Stephan Brady -
New Balcony

Details

A-200

① Detail - Beam/Beam
1 1/2" = 1'-0"

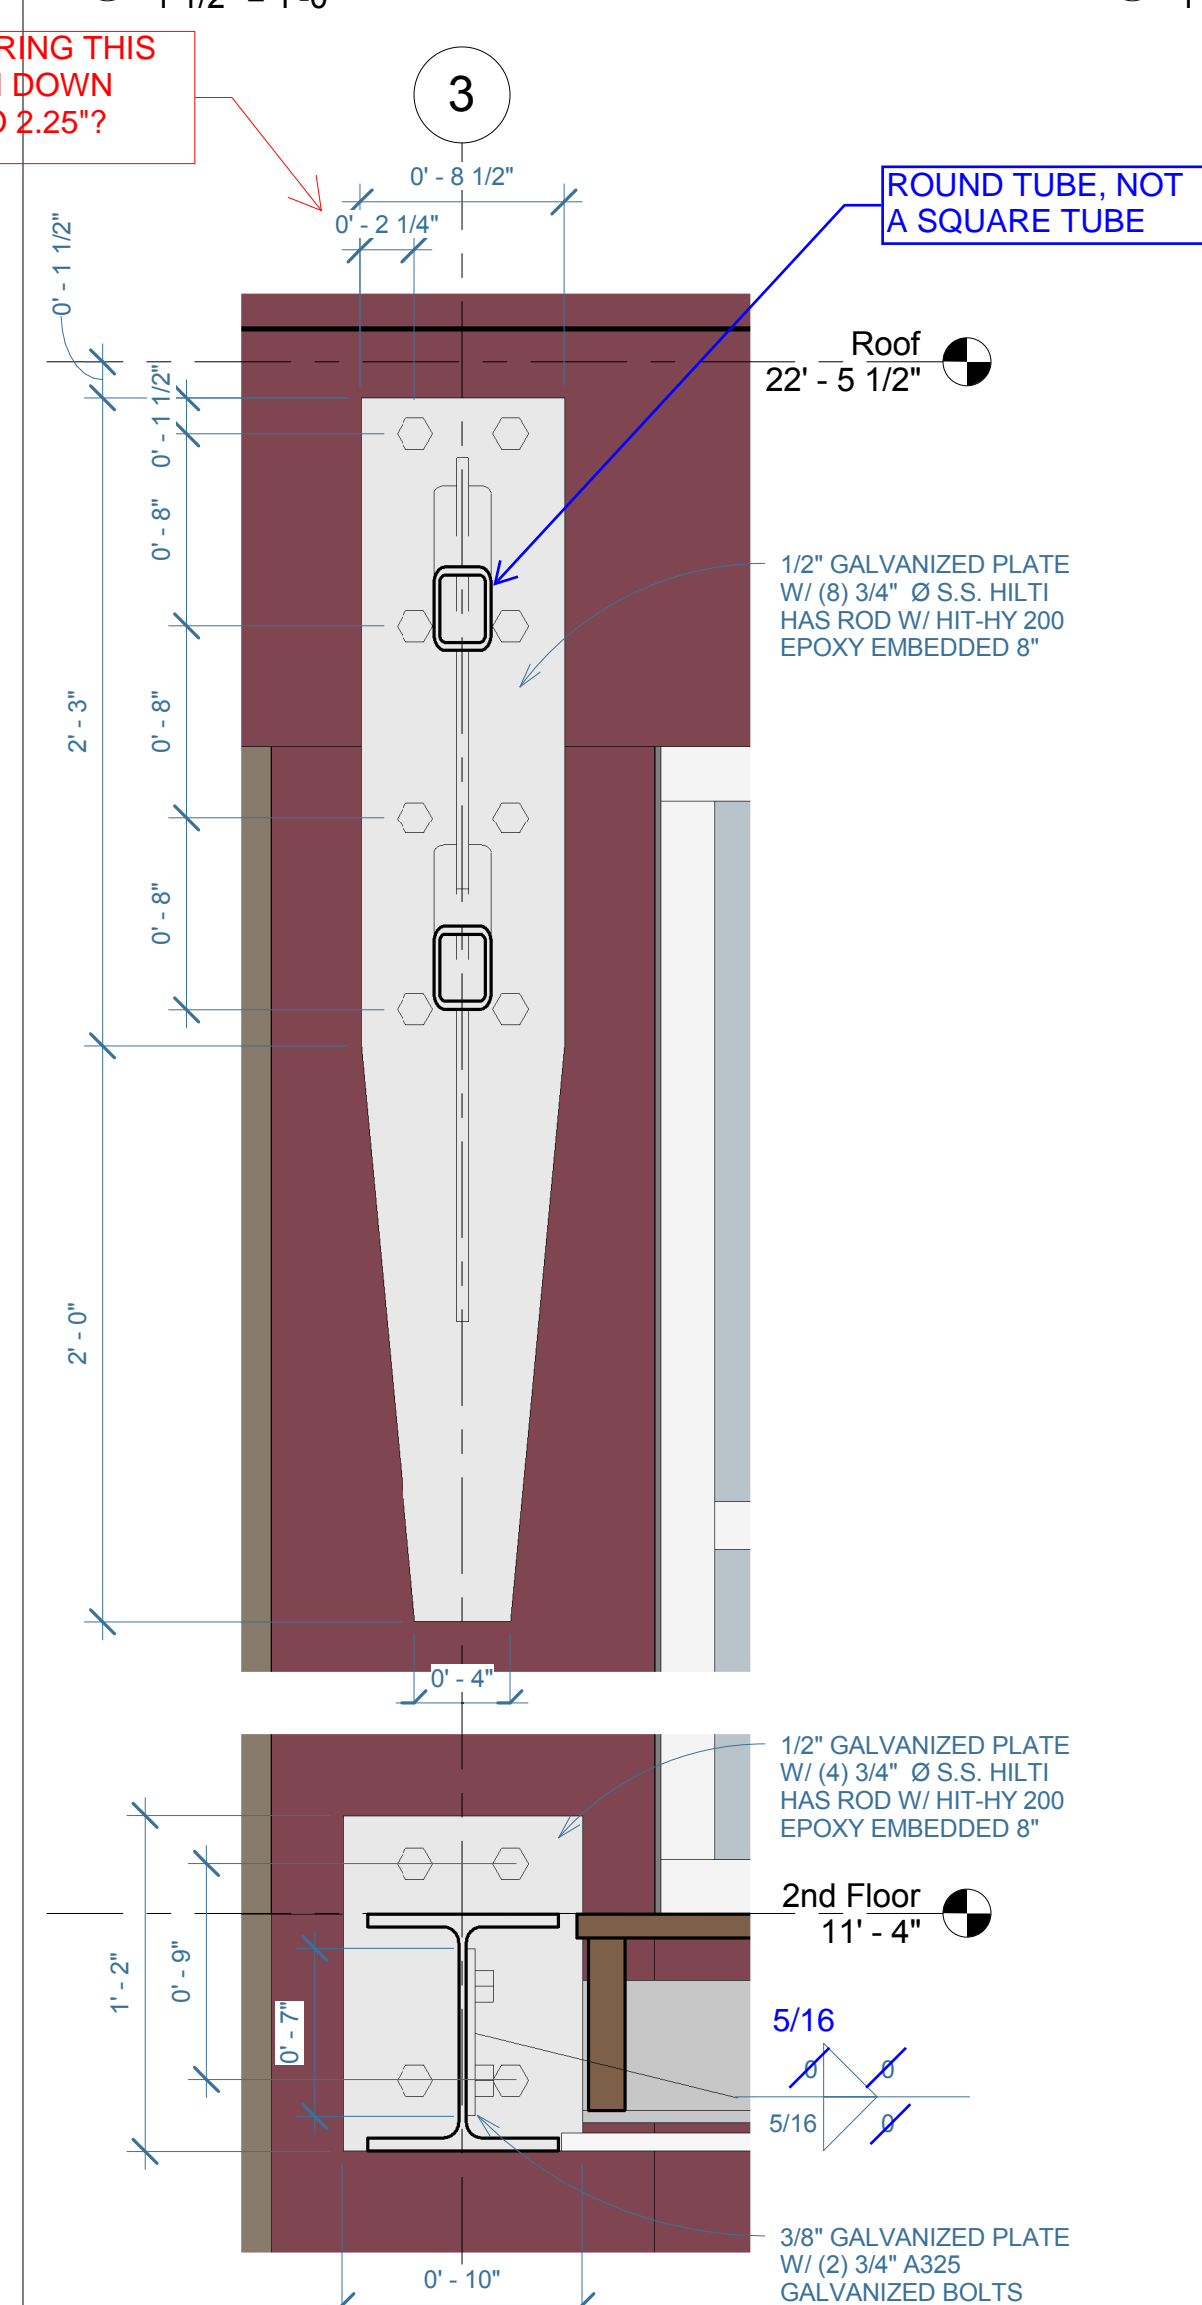
OKAY TO BRING THIS DIMENSION DOWN FROM 3" TO 2.25"?

ROUND TUBE, NOT A SOLID TUBE

YES
